## Memorandum

Subject: DR-16-01 – Supplemental Staff Report

**ADDENDUM TO NARRATIVE OF APPLICABLE REGULATIONS AND ASSOCIATED SUPPLEMENTAL FINDINGS DR-16-01, CHAPTER 58, WILLAMETTE FALLS DRIVE COMMERCIAL DESIGN DISTRICT, PRESENTED AT MAY 17TH HISTORIC REVIEW BOARD MEETING**

NORTH ELEVATION

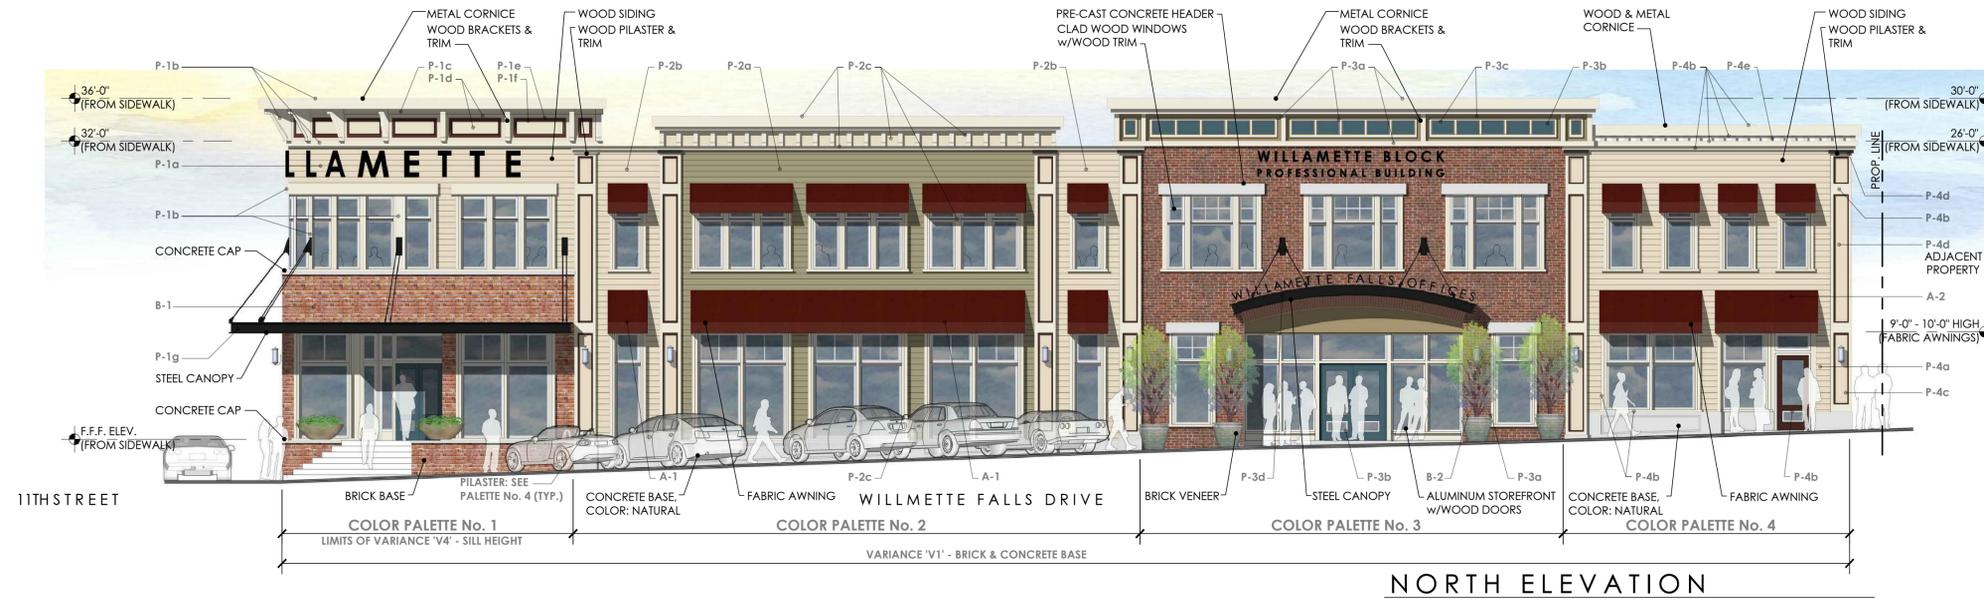
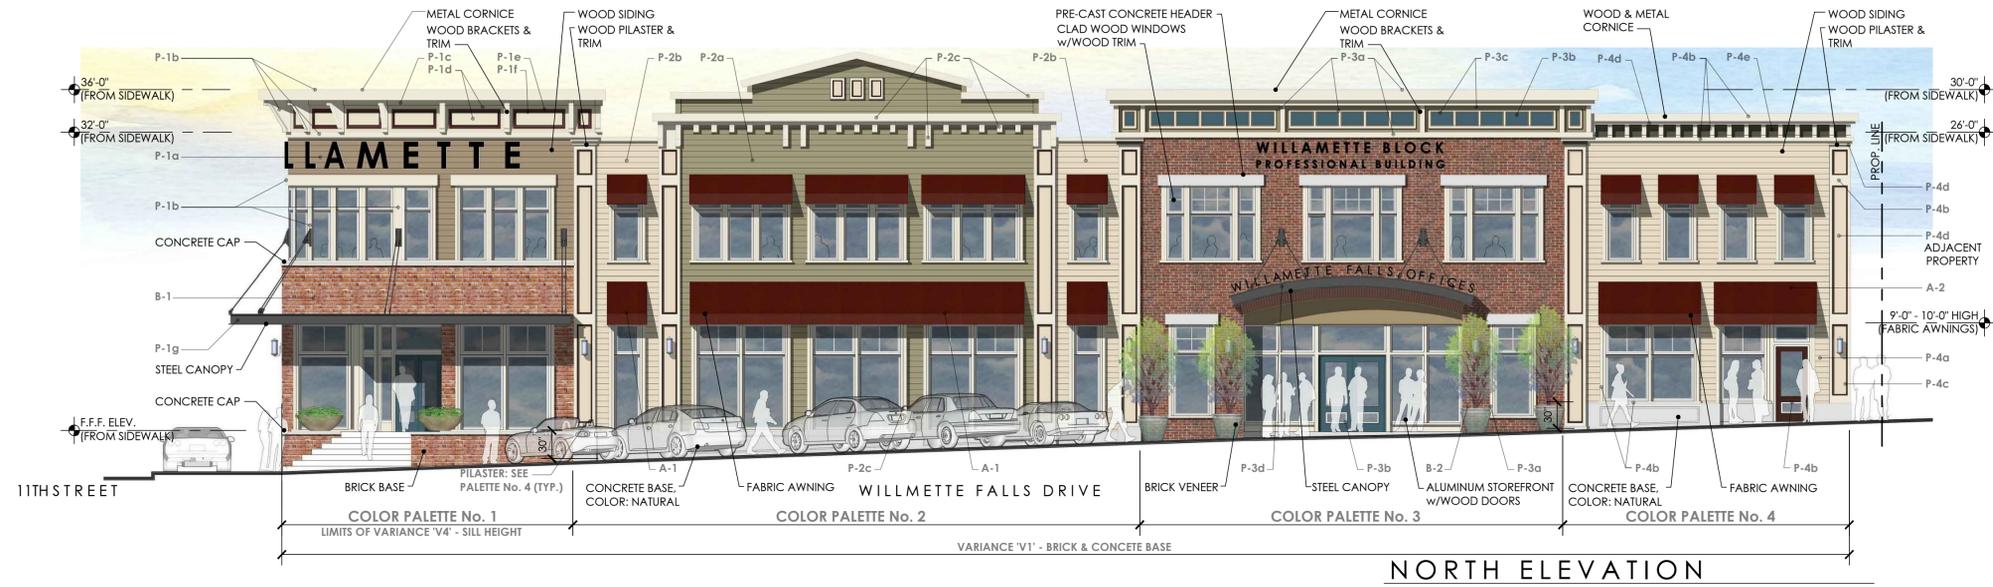
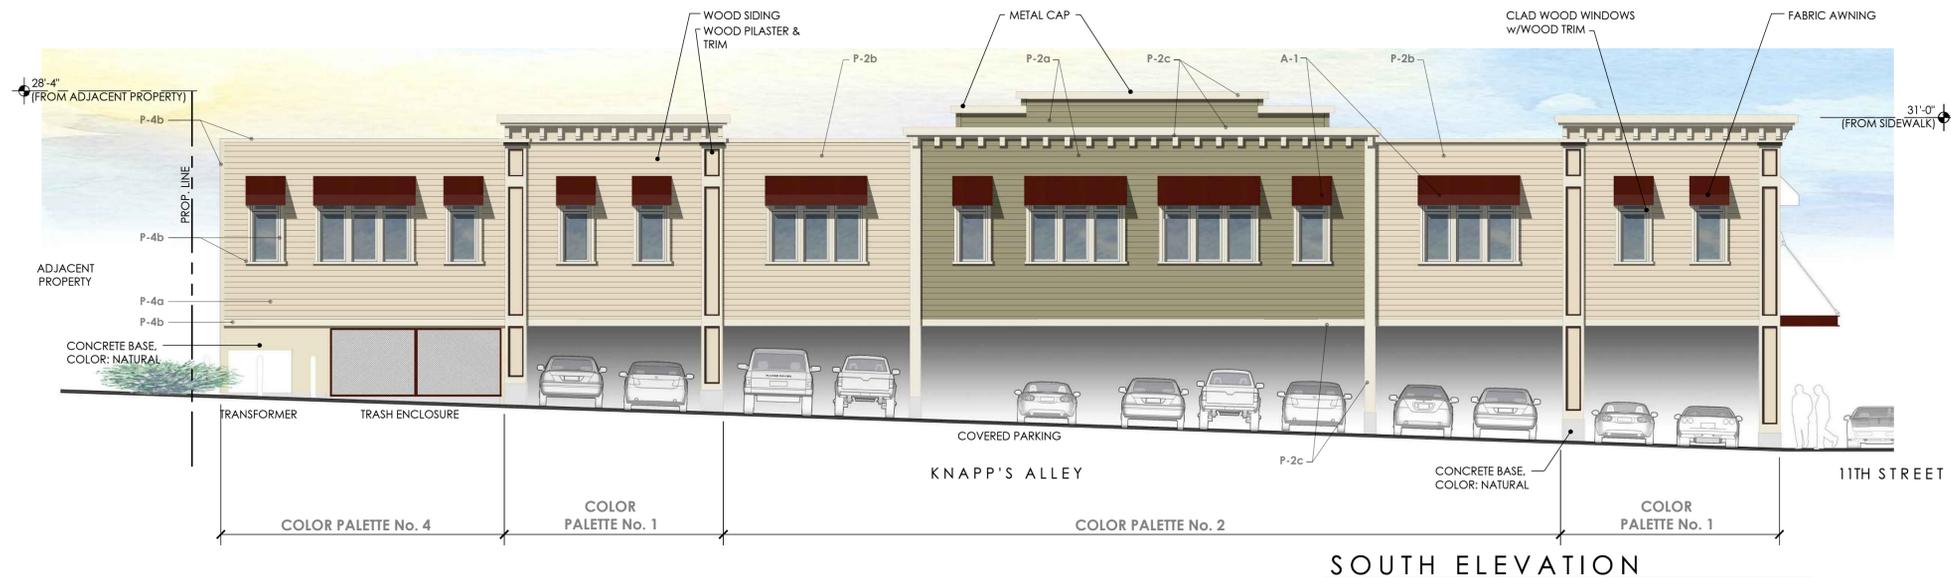
The applicant has eliminated the need for requested variance 3 through the use of doors that comply with the code. The applicant has also redesigned the front elevation to bring all but the eastern most windows into compliance with the maximum 30 inch sill height of pedestrian level windows. Variance 4 is still needed, but only for two windows. The applicant has proposed changing some of the brick masonry base to concrete to break up the front façade. Additionally, differing brick blends will be used to further divide the front façade. Please see the revised findings below.

**in the original design, the windows at the western-most portion of the elevation were already in compliance, and have not been changed. The windows in the western masonry facade have been lengthened to bring the sills into compliance with the Standard.**

**The remaining pedestrian level windows on the proposed design have been lengthened to have the sills lowered to the finished floor line. This as succeeded in bringing all but the windows in the eastern-most rounded corner portion of the building into compliance.**

**The proposed design has been revised to alternate brick and concrete at the building base, which serves to break up the continuous brick wainscot that raised concerns at the May 17th HRB meeting. Further, this has allowed us to provide a different brick blend at each of the brick facades, which will help to further divide the facade into multiple 'buildings'.**
